## Turbo HD DVR V3.5.30 Build171209 Release Notes (2017-12-13)

### Reason of Upgrade

Release Turbo 4.0 DVR new models: DS-7204HTHI-K1、DS-7204HTHI-K2、DS-7208HTHI-K2. Most HU series newly support 8MP TVI, add some new functions, modify some functions, enhance products quality and meet customers' requirements.

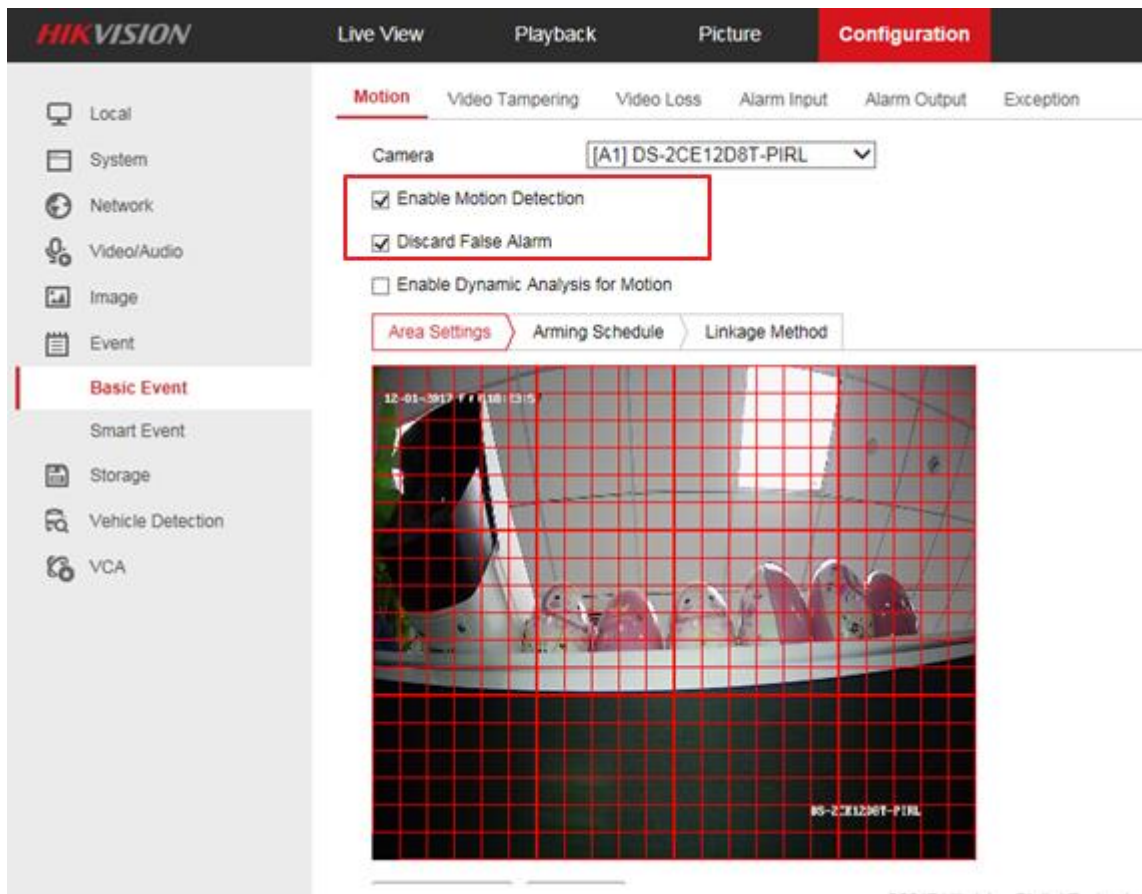
- vi. When the analog channel is connected to the PIR camera, K series DVR can reduce the false alarm combing the PIR alarm for motion detection.

Configurations of local GUI and web page are as below:

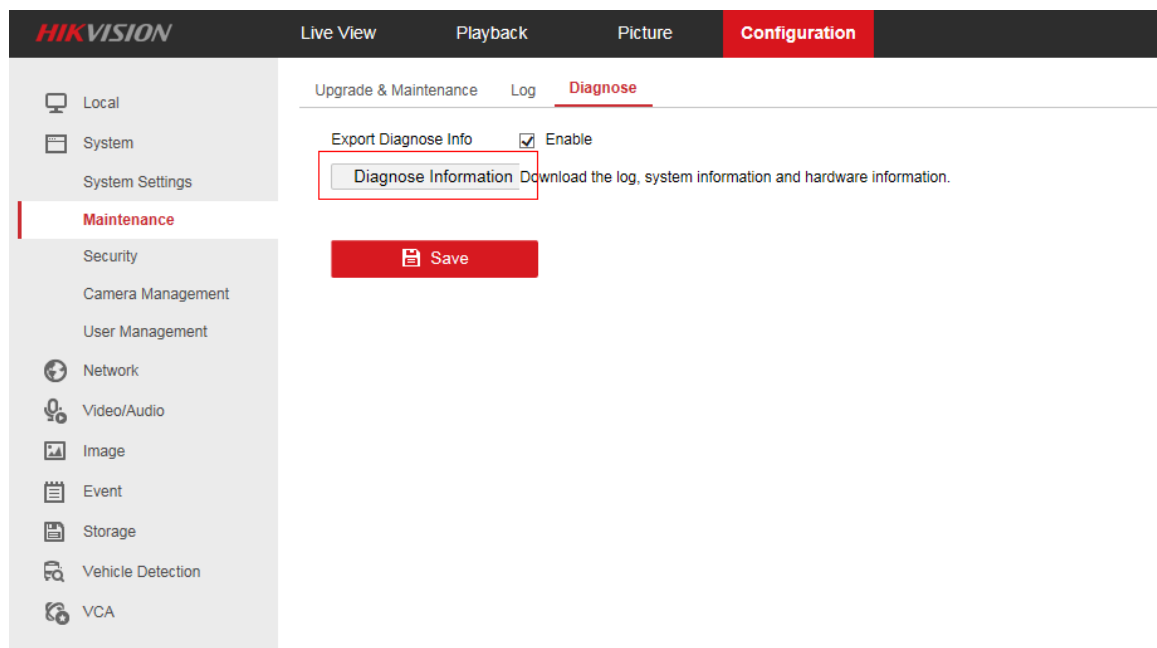
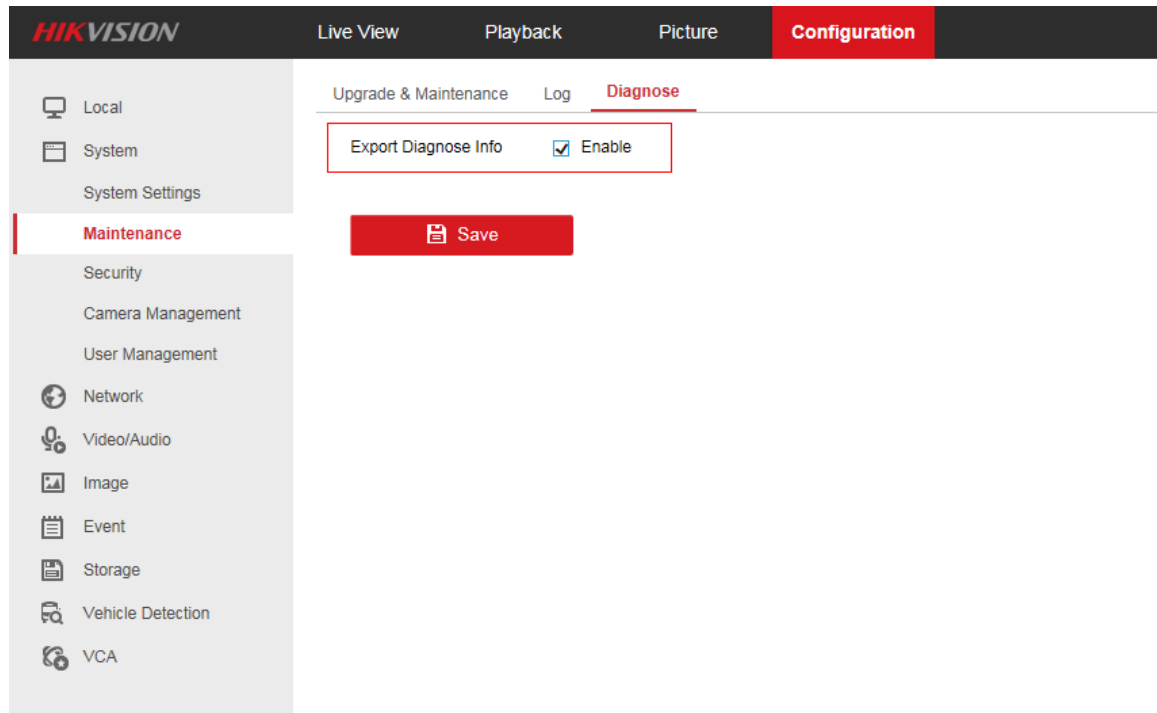
- vii. Newly support to export the diagnostic information of device via web remotely and the exported information is saved in the form of a file.

Configurations of local GUI and web page are as below:

1. Enable Export Diagnose Info firstly;
2. Click the Diagnose Information button to save the diagnose info;
3. The diagnose information records the running status of the device, which is very useful to solve the customer issue. The diagnose information is encrypted (If you open it directly, it will show some random code) and only the R&D have the authority to decrypt.

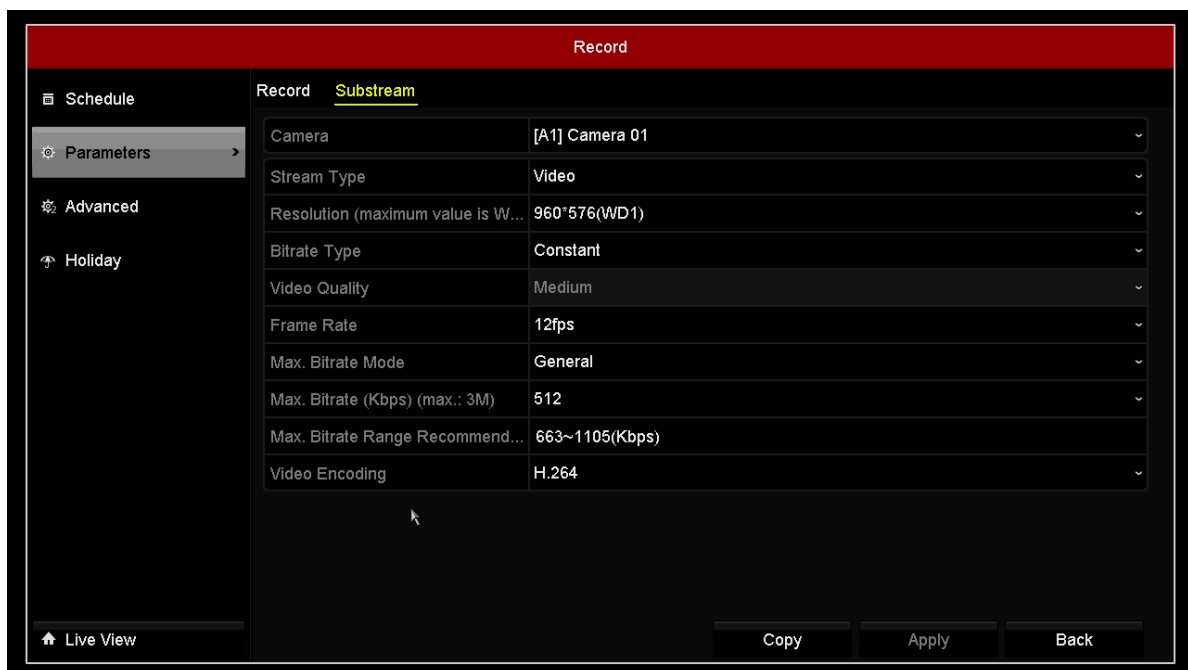
- i. 72HUHI-K series DVR support more IP channels. 7208HUHI-K support 4-ch IP cameras while 7216HUHI-K support 8-ch IP cameras.
- ii. 73HQHI-K series IPC access capability is upgraded to 6MP.
- iii. 73HQHI-K support SNMP.
- iv. The default encoding parameter of the sub-stream is raised to improve the definition experience of the remote preview. Sub-stream encoding default parameter adjustment is as follows: CIF@real-time/512Kbps-->WD1@12fps/512Kbps.
